From: Chad A. Millner, PE, Director of Engineering

Date: March 3, 2015

Subject: Valley View Road Design Modification– Birchcrest B Neighborhood Roadway Reconstruction, Improvement No. BA-410

Figure 1. Curb Shifted but No Driveway Slope Change

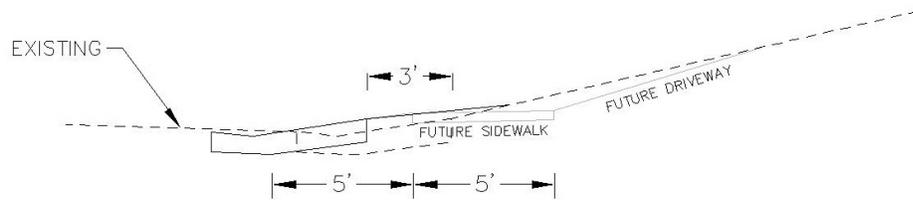
If the council determines it is in the best interest to re-align, we would need to consider changes to driveways slope. Below, Figure 1 shows the curb shifted but no change in driveways slope to accommodate a future sidewalk. This option would have more impacts during future sidewalk installation because it would require removing driveway pavement and aprons that most likely have not reached the end of their useful life.

Figure 2. Curb Shifted with Driveway Slope Change

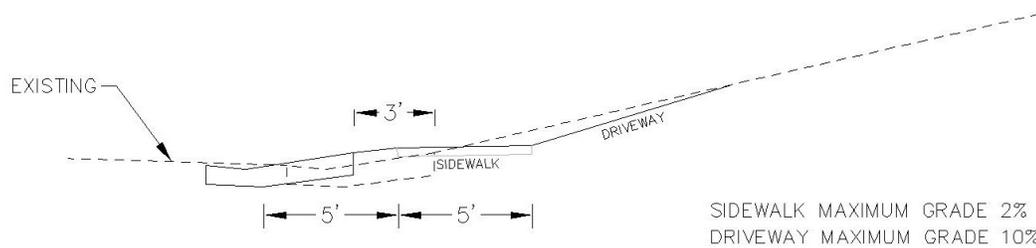
Figure 2 shows the curb shifted with changes to the driveways slopes for a future sidewalk. The curb re-alignment and driveways slopes could be designed so that less pavement would be removed during future sidewalk installation. This would greatly reduce impacts and not require replacing the same pavement twice before the end of its useful life.

Staff recommends approval of Option #3 that modifies both Valley View Road alignment and driveway slopes in order to accommodate a future sidewalk. If council approves these changes, staff will redesign Valley View Road with these changes. This would occur in March allowing ample time to get the contractor undated plan sheets prior to construction. The additional cost of \$110,000 would be funded by a combination of storm sewer utility and Pedestrian and Cyclist Safety (PACS) funds at \$50,000 and \$60,000, respectively.
